TITLE: **MB 210 PREAMP**

FILENAME: 6550B2.SCH

REV. **B2**

DRAWING NO: 1206-0550-B2  
PART NO: 206-0550-B2

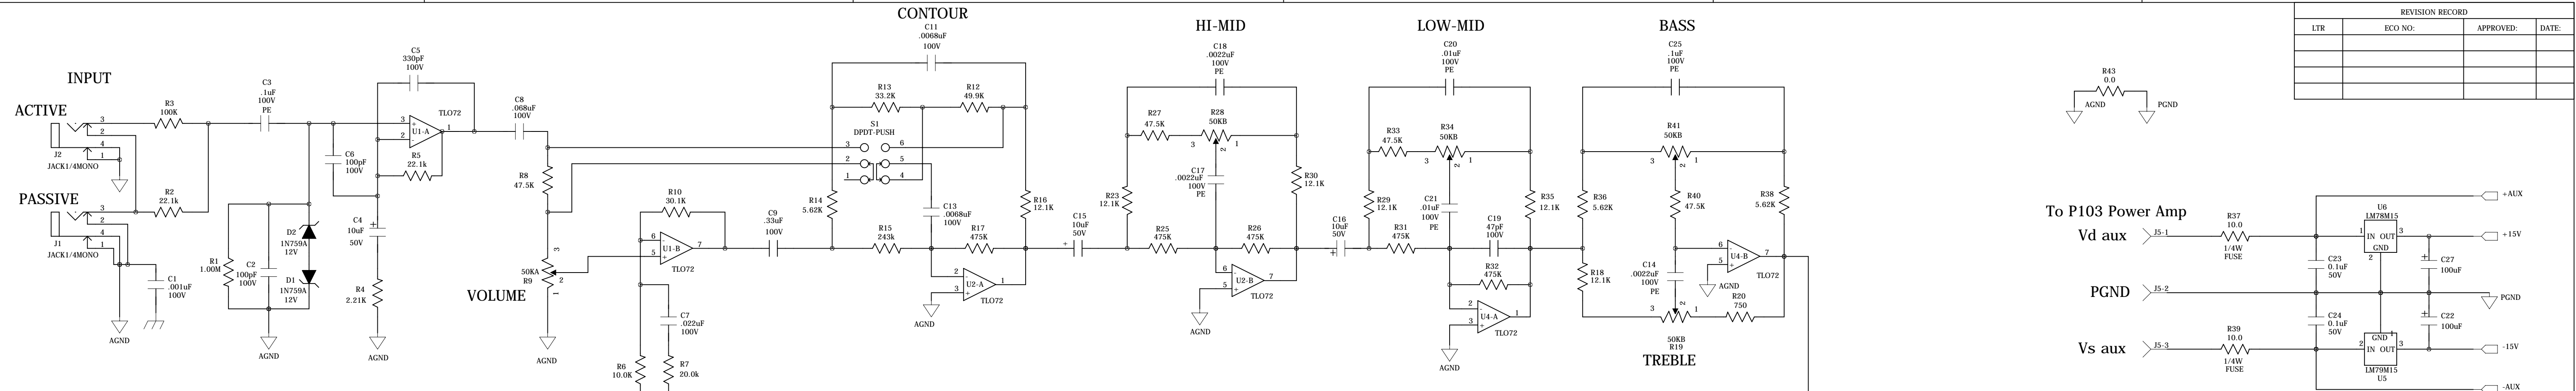
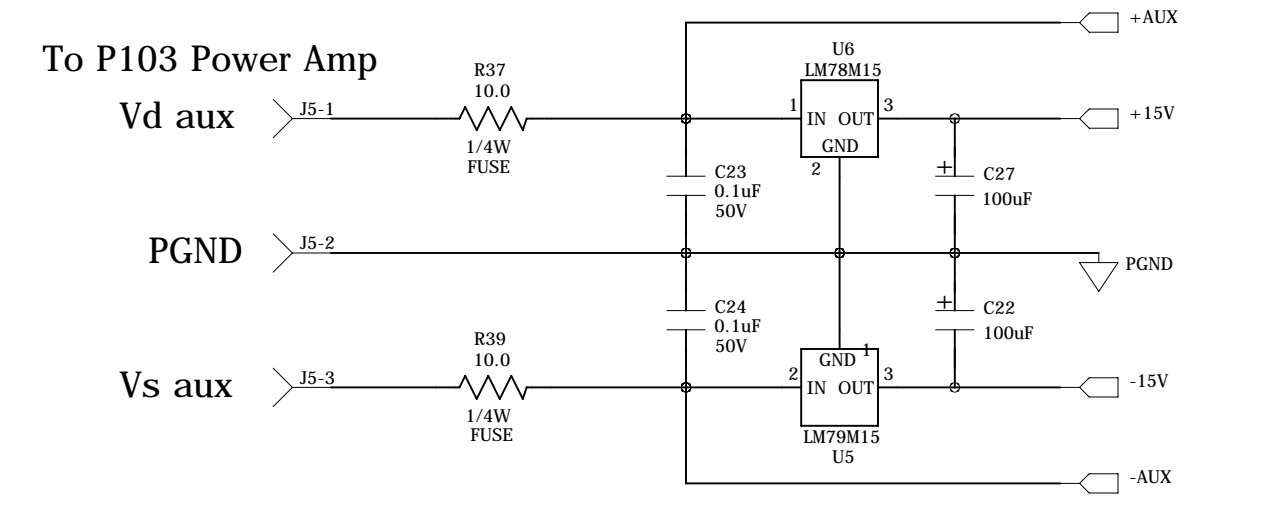
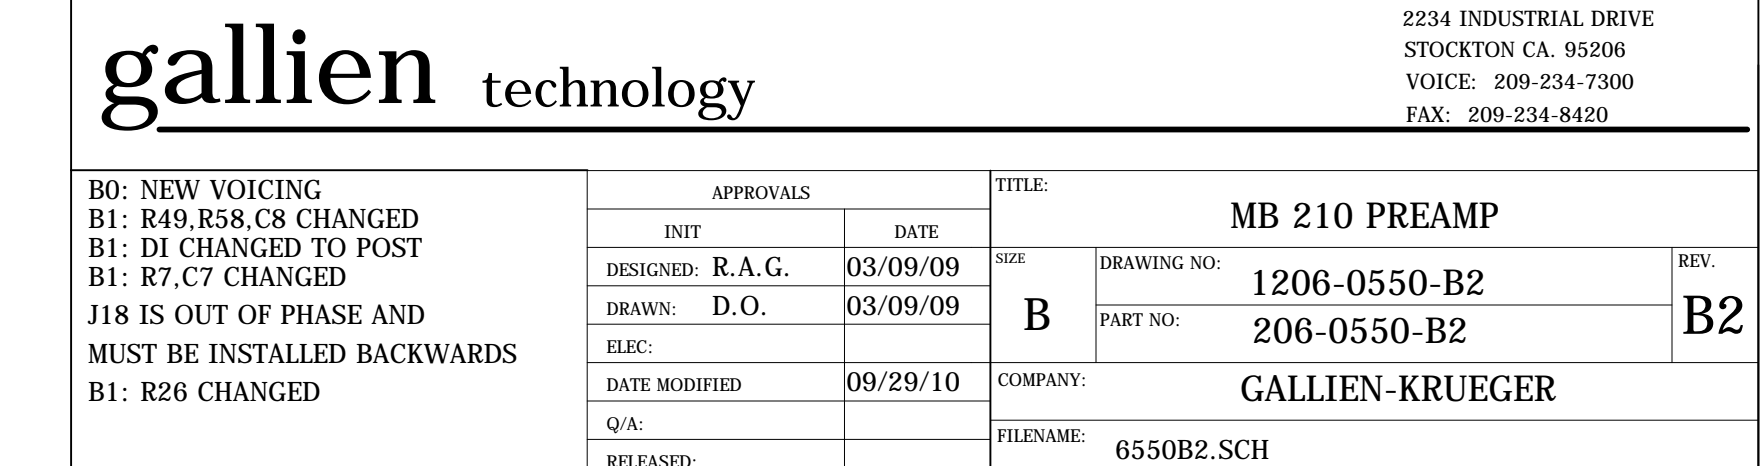
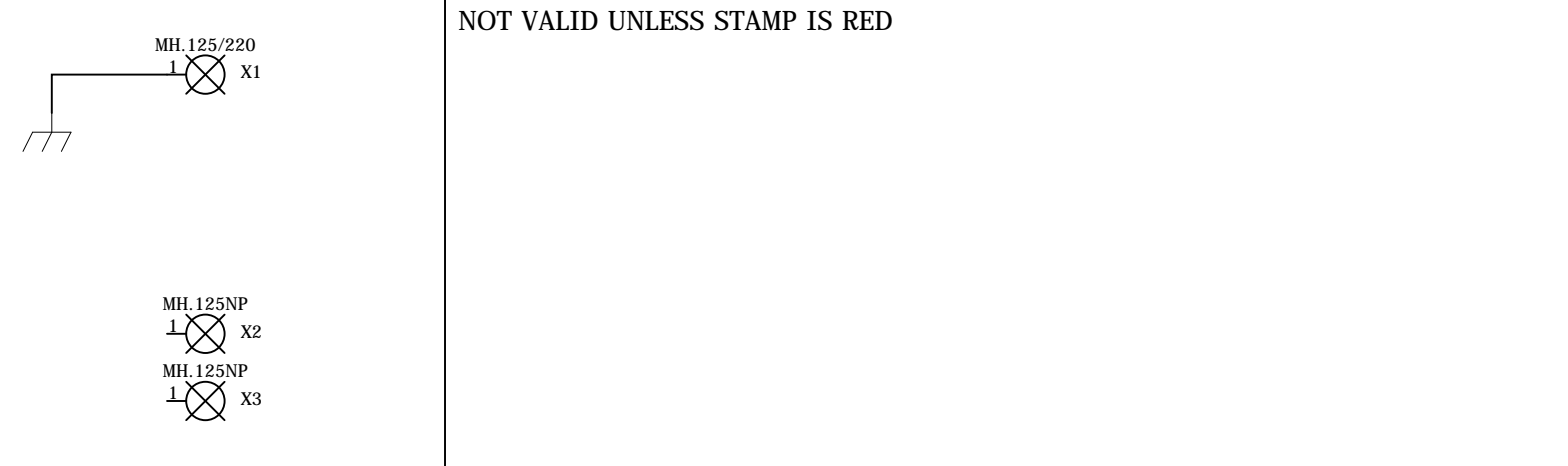
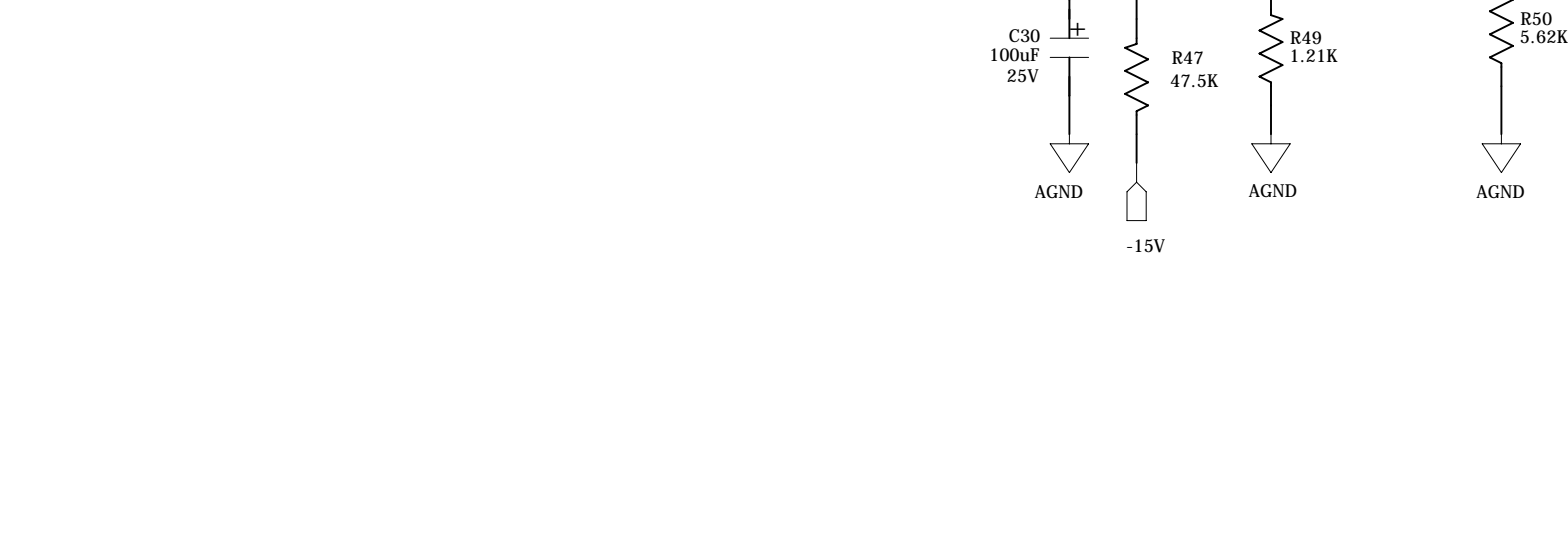
BO: NEW VOICING  
B1: R49, R58, C8 CHANGED  
B1: D1 CHANGED TO POST  
B1: R7, C7 CHANGED  
J18 IS OUT OF PHASE AND MUST BE INSTALLED BACKWARDS  
B1: R26 CHANGED
